### **REMARKS**

#### ***Objection to the Disclosure***

FIG. 3

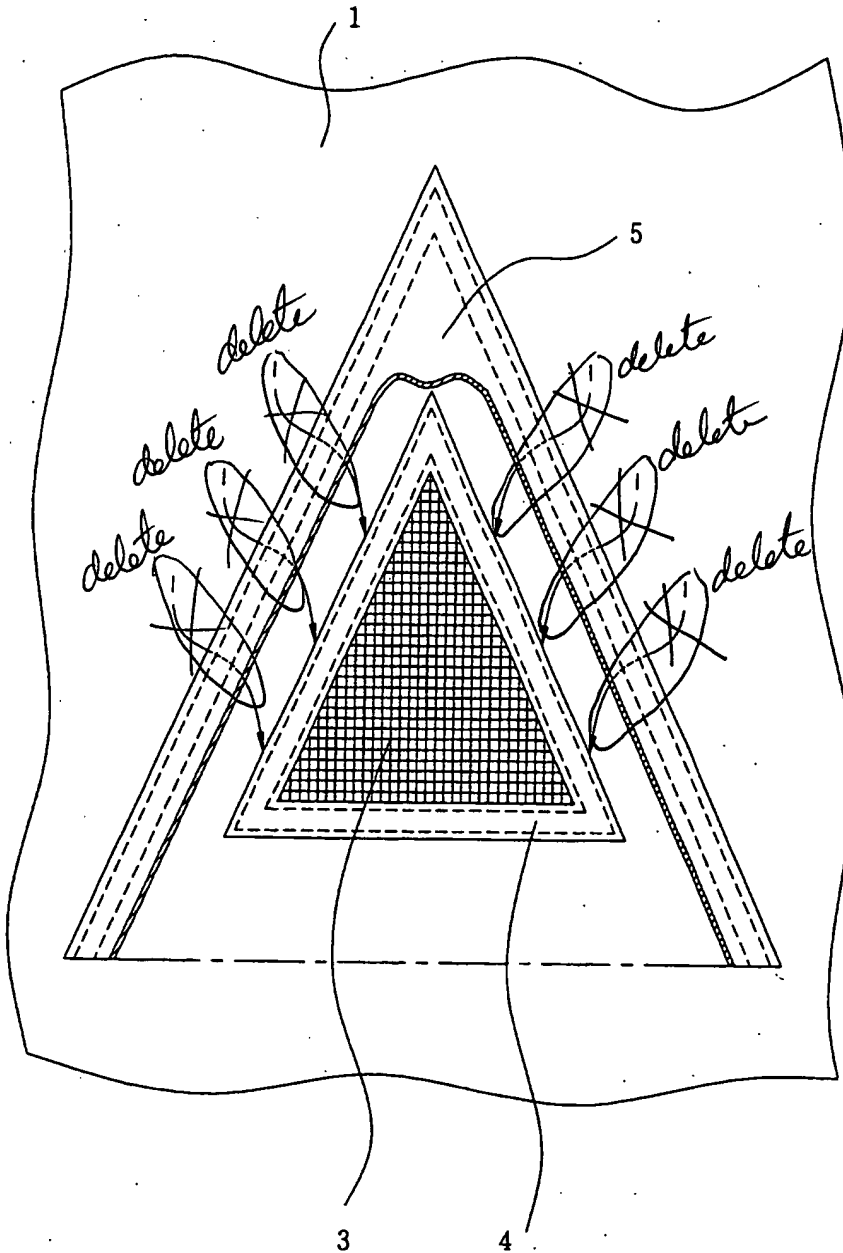
Figure 3 of the drawing stands objected to because reference numeral 1 has been used to designate more than one element. Applicant submits that six arrows in the middle of the drawings were used to show the rainwater penetration. In order to remove the confusion, Applicant has removed those arrows. Applicant herewith submits a replacement drawing for figure 3 in compliance with 37 CFR 1.121(d).

FIG. 4

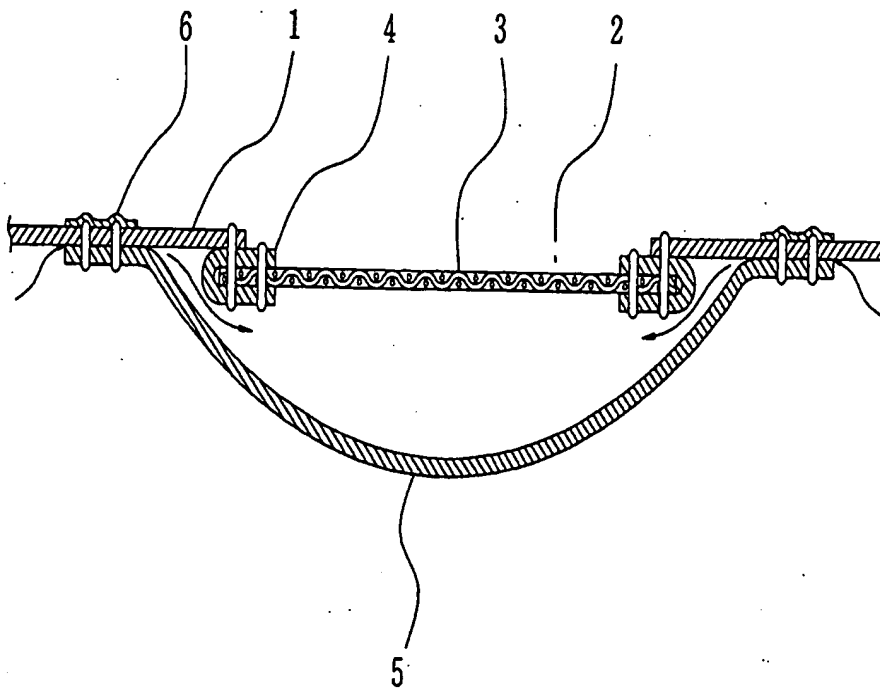
Figure 4 of the drawing stands objected to because a legend such as --Prior Art—is required. In response, a replacement drawing including the legend is submitted herewith.
